I, Stephen Daldry CBE, am writing to object the development of Rear Of 1-3, Britannia Street, London, WC1X 9BN (ref: 2016/6356/P) in its current form. The development will cause considerable harm the use and enjoyment of my property 5 Britannia Street, with considerable regard to massive loss of light. The objections, and suggested solutions are listed below.

Exhibit 1.1 from (see p43 on Daylight and Sunlight Report)

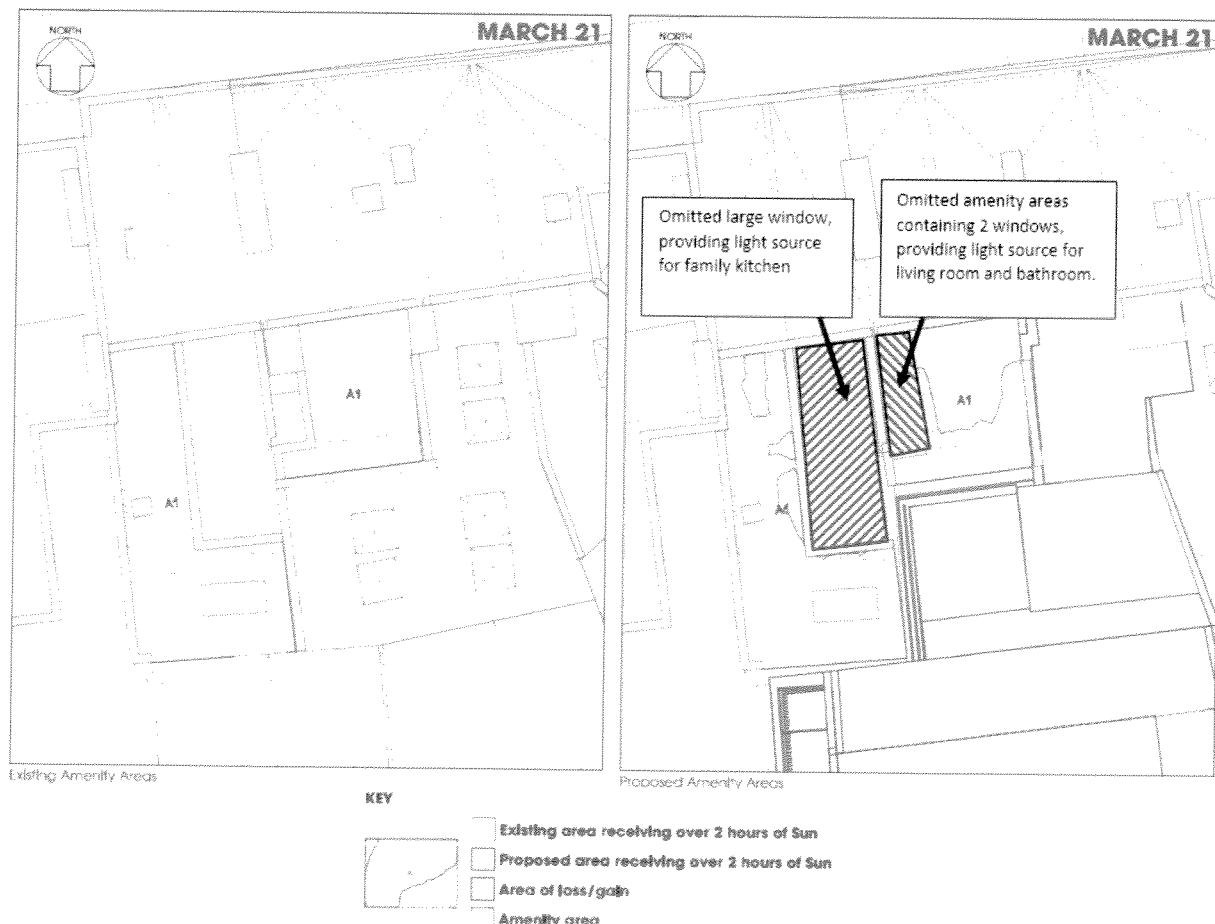
- The skylight window of my kitchen is the primary source of light for the kitchen and only source of direct sunlight for the room. The Daylight and Sun report completely omits this very large (12ft by 6ft) and easily observable window, even though it is easily observable and will be the most affected window. There is no conceivable way that the author of the Daylight and Sunlight Report could have accidentally missed this window, indeed it is discounted from the amenity area, suggesting they knew about its existence but left it out the report.

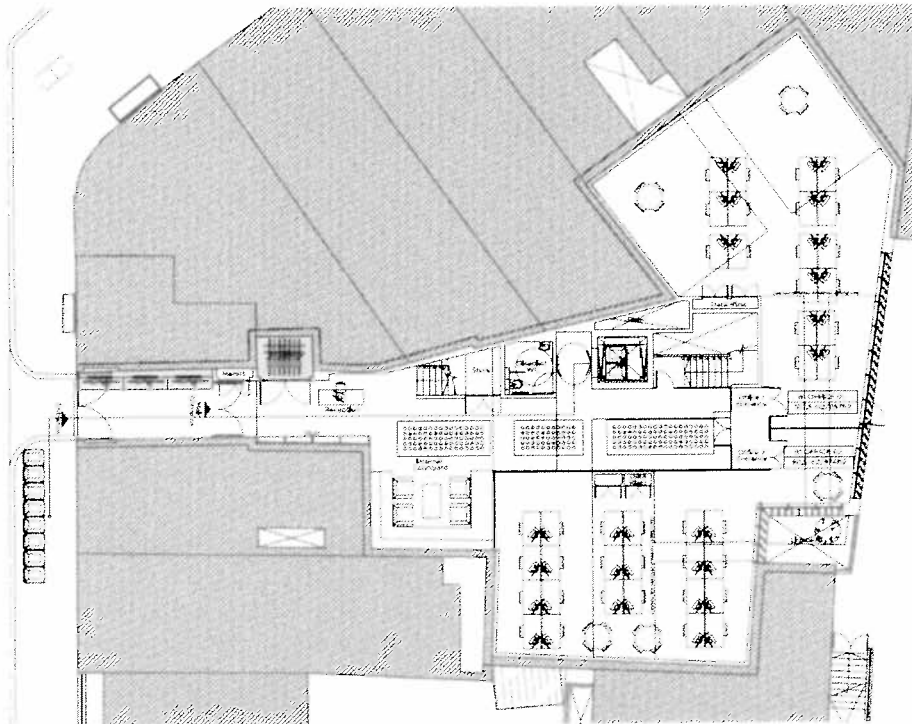
- The below diagram shows that for waste disposal 8 x 240 litre bins will be placed in front of 3 and 5 Britannia Street.

- While the DAS suggests that these will be placed on the street on the day of waste disposal and removed thereafter, they provide no plans or measure on how this is to be accomplished suggesting lack of research and knowledge of the surrounding area.

- Rubbish on Britannia Street is collected 3 times a week on Monday, Wednesdays and Fridays. It is typically collected early in the morning normally before office hours. This means the new development would have to leave 8 bins in front of our property of my property and the neighbouring 3 Britannia Street from the close of business (17.00) until opening of business (9.00am) the next day.

- This means that rubbish will be amassed in front of our property for at least 16 hours three times a week, creating a potentially unsafe environment for residents.

- **Secure off street storage for collection with private collection:** The reasonable solution is for the development to plan to storage waste for collection within their property, as opposed to on the street, and either have private waste collection recover it from there.
